**Advanced Passive 1000 (AP1000)
Generic Technical Specification Traveler (GTST)**

Title: Changes Related to LCO 3.7.12, Spent Fuel Pool Storage

3.7.12 Spent Fuel Pool Storage

Figure 3.7.12-1 (page 1 of 1)
Minimum Fuel Assembly Burnup Versus Initial Enrichment for Region 2 Spent Fuel Cells

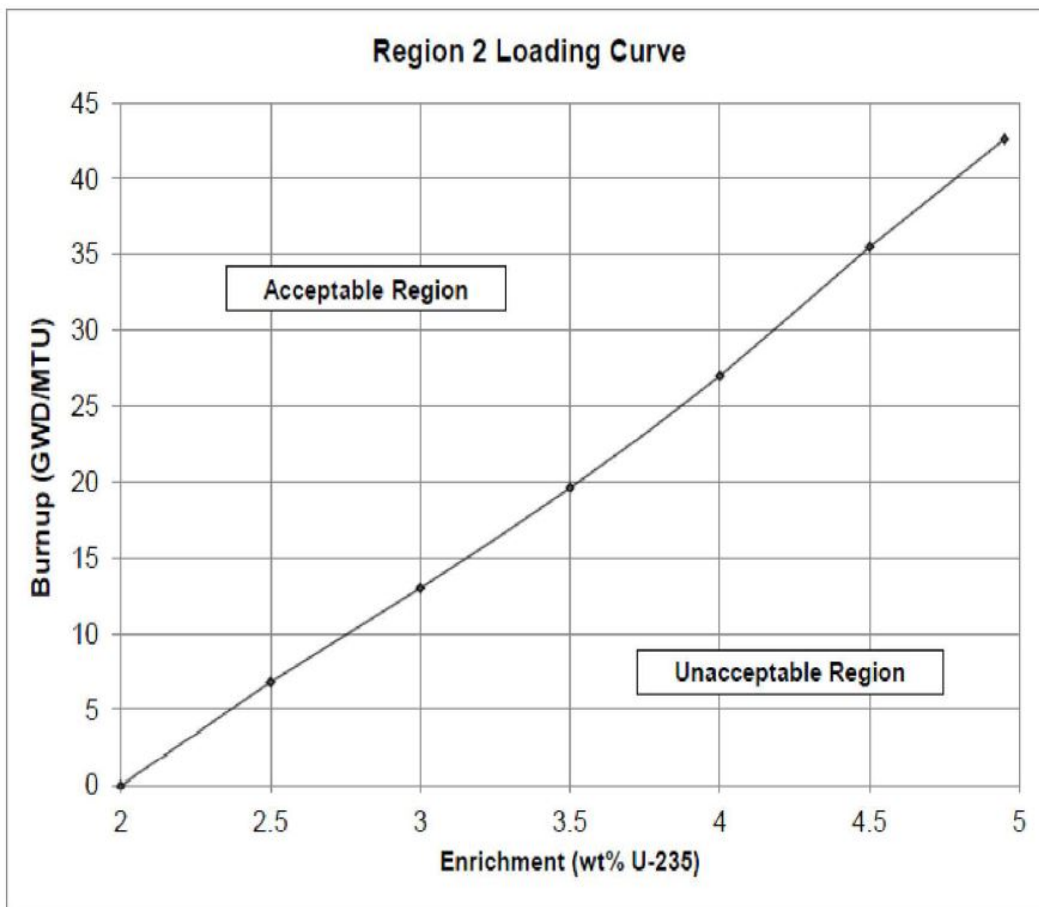
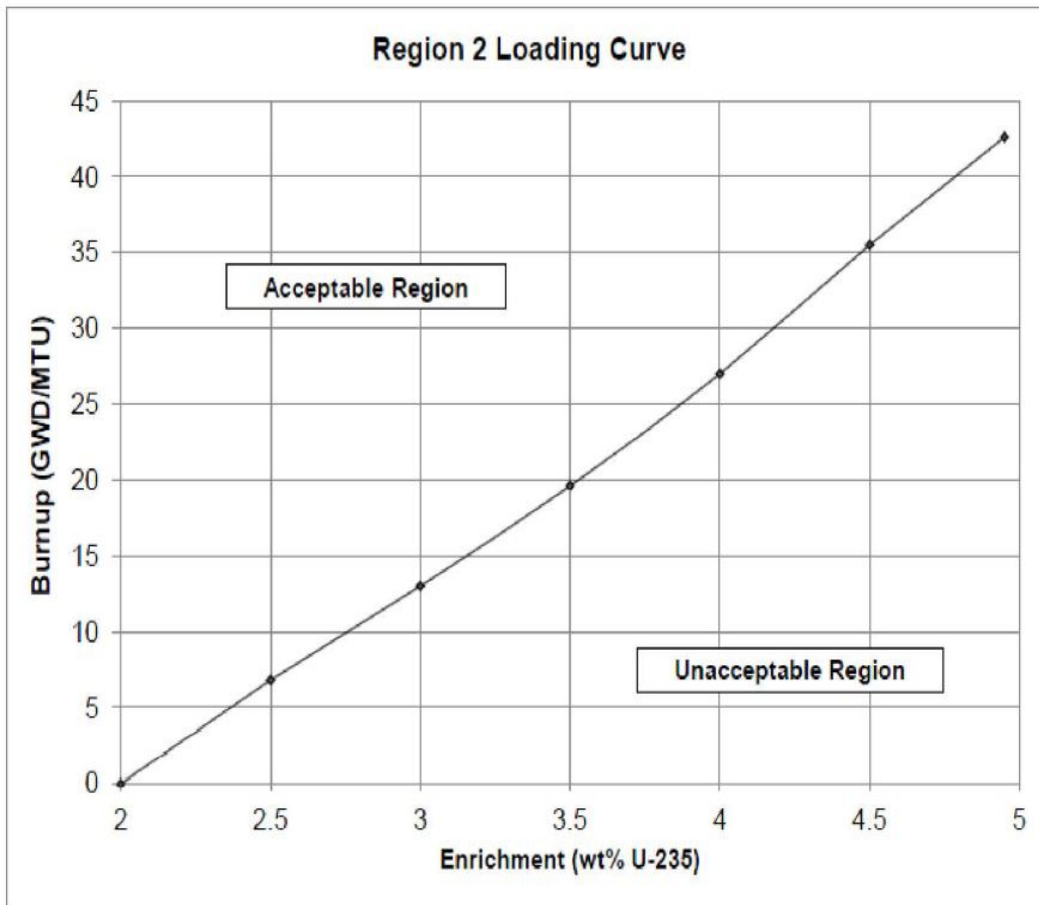
VEGP LAR DOC A003: References to various Chapters and Sections of the Final Safety Analysis Report (FSAR) are revised to include FSAR.
VEGP LAR DOC A105: Correct references to Spent Fuel Pool
VEGP LAR DOC A111: Revision of Figure 3.7.12-1
VEGP LAR DOC L05: TS LCO 3.0.8 is eliminated

GTS Figure 3.7.12-1 is revised by adding area labels to provide clarity. (DOC A111)

DOC A111 annotates the acceptable and unacceptable regions for loading on Table 3.7.12-1.

DOC A111 provides clarity in interpretation of Table 3.7.12-1.

Region 2 permits storage of spent fuel assemblies in any cell location provided the assembly meets the combination of initial enrichment and burnup shown in LCO Figure 3.7.12-1, Minimum Fuel Assembly Burnup Versus Initial Enrichment for Region 2 Spent Fuel Cells. **The Acceptable Region of the Figure is to the left and above the curve.**
